ACTION TRANSMITTAL 2016-07

DATE: December 4, 2015
TO: TAC Planning
FROM: MTS Staff
PREPARED BY: Rachel Wiken (651) 602-1572
SUBJECT: Functional Class Change #1330 – Planned A Minor Connector
Ridgeway Crossing– City of Dayton
REQUESTED ACTION: City of Dayton requests this functional class change be approved.
RECOMMENDED MOTION: Staff recommends approval of the request with the modification to A Minor Expander and a change to functional class on Brockton Lane when planned road is completed.

Regional Functional Classification Change Request Form

ID Number: 1330

Functional Class Roads Change Requests

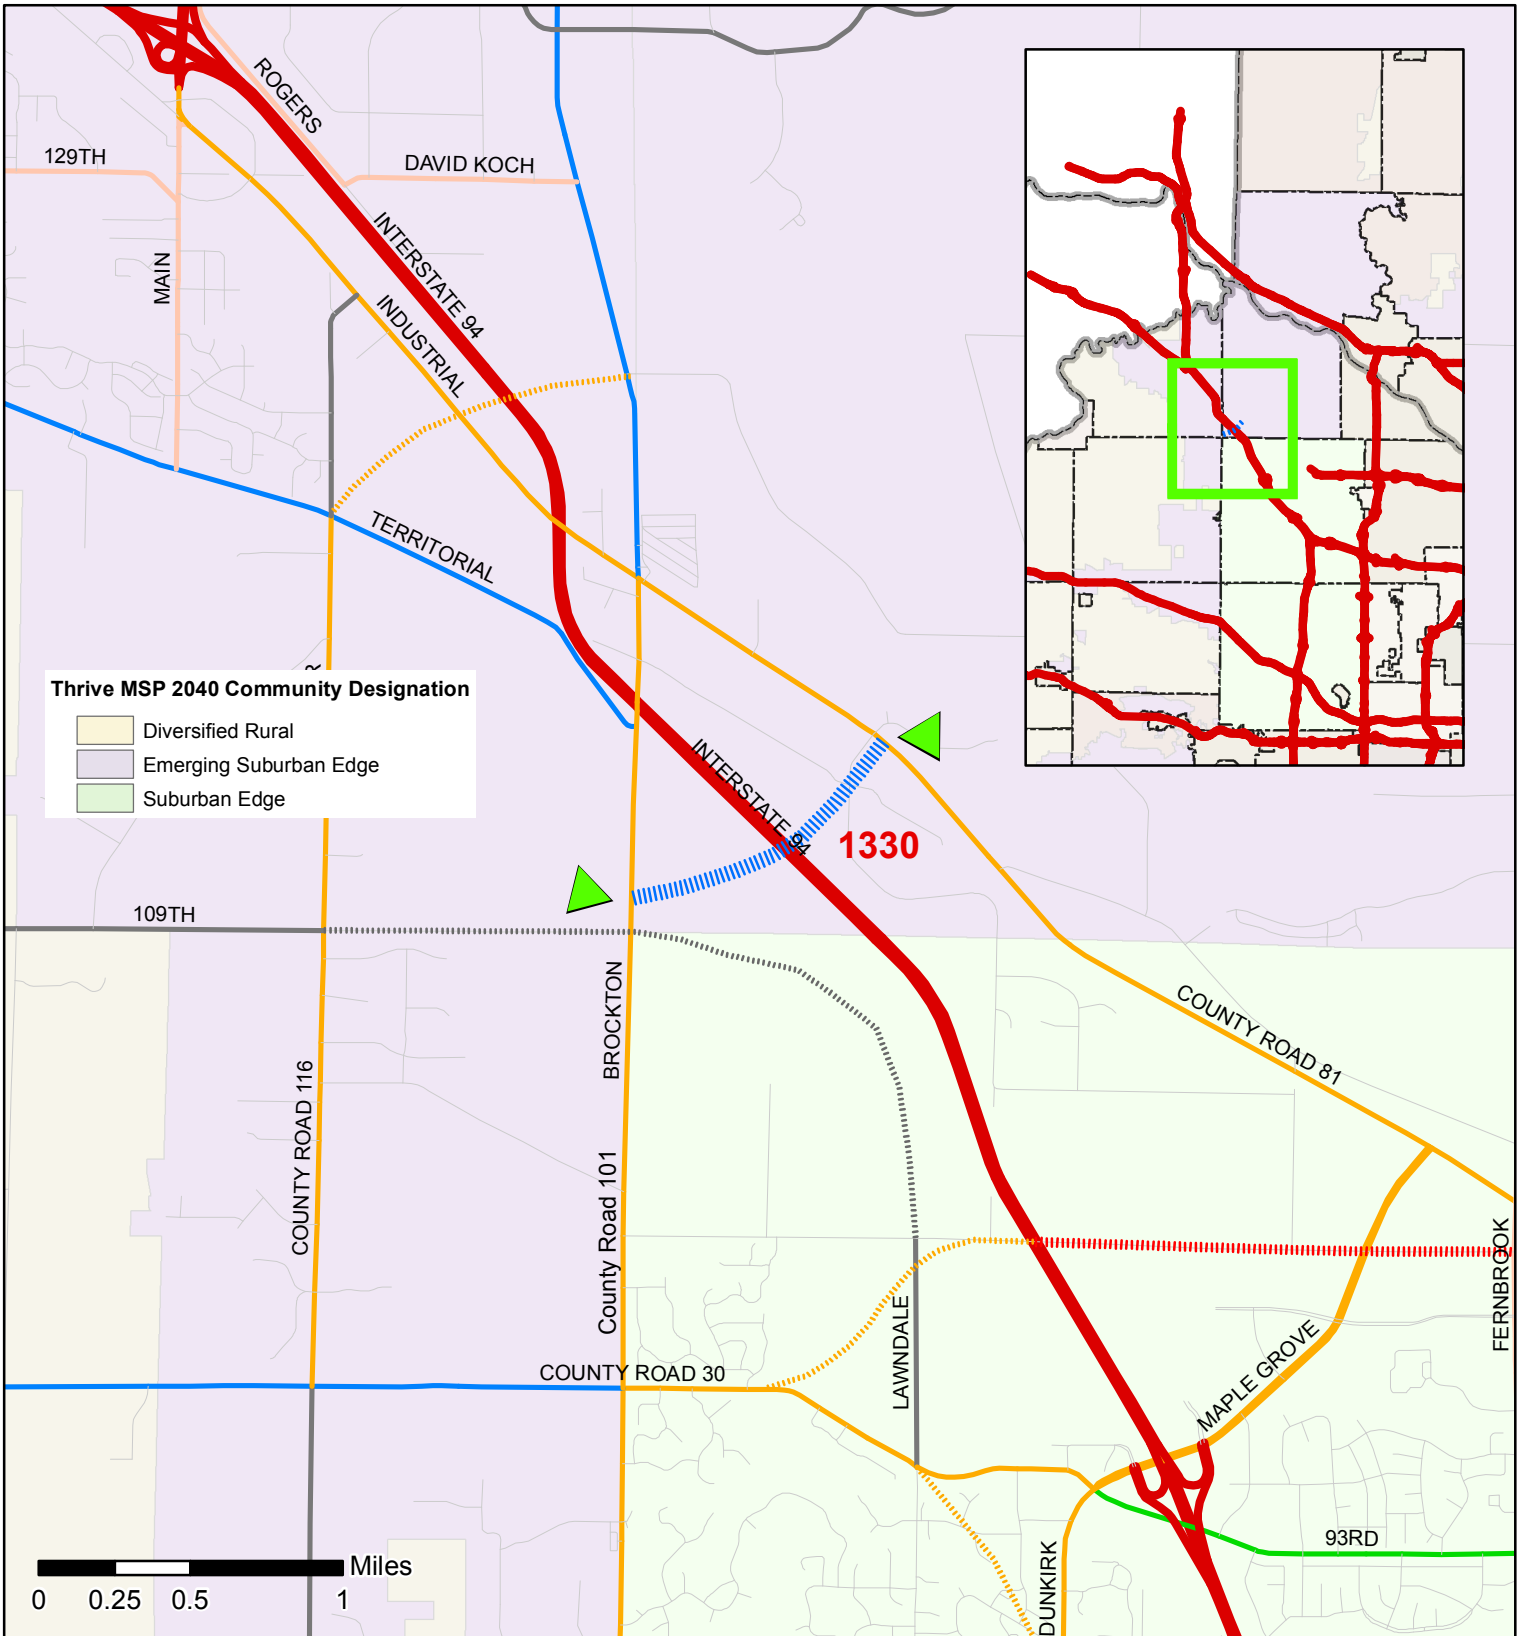
City of Dayton is classified as an Emerging Suburban Edge in Thrive MSP Community Designations. Based on the 2040 Transportation Policy Plan Appendix D: Functional Class Criteria, A Minor Connectors are in rural communities. A Minors in Suburban / Suburban Edge areas should be classified as Expanders. Based on the Thrive MSP community designations, an A Minor in the City of Dayton should be A-Minor Expander instead of a Connector.

Staff also recommend that if the planned road is approved, a subsequent change be required upon completion of the planned road. Brockton Lane from CSAH 81 to the new planned alignment should be changed from Expander to Connector. The new planned road and Brockton, if both were expanders, would cause redundancy on the A Minor system.

MnDOT Staff also highlighted that the application ignores the completion of 610 and the new connection to I-94 which would narrow the gap in access points. With the completion of 610, the gap in access would be closer to 5 miles. Completion of 610 will also improve local streets in the area. Spacing of access points would still be acceptable and within guidelines.
